Subject: Pre-Application Summary Notes for THPRD Schiffler Park Restroom

THPRD Schiffler Park Restroom PA2022-0018, June 29, 2022

Project Description: Construction of a permanent restroom in an existing park in a residential zone.

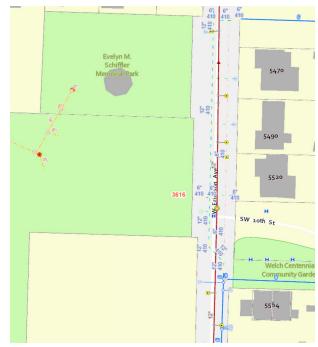
• COB is the water provider for the Schiffler Park Site. There is a 6" Waterline running along SW Erickson Ave ending just north of 5564 SW Erickson Ave. There is a 12" COB Sanitary Sewer line running along the length of SW Erickson Ave . A COB SPL will be required for connection to the COB Water Line.

• A CWS SPL may be required for ground disturbance. COB will require a completed CWS Pre-Screen Site Assessment to be submitted with the application.
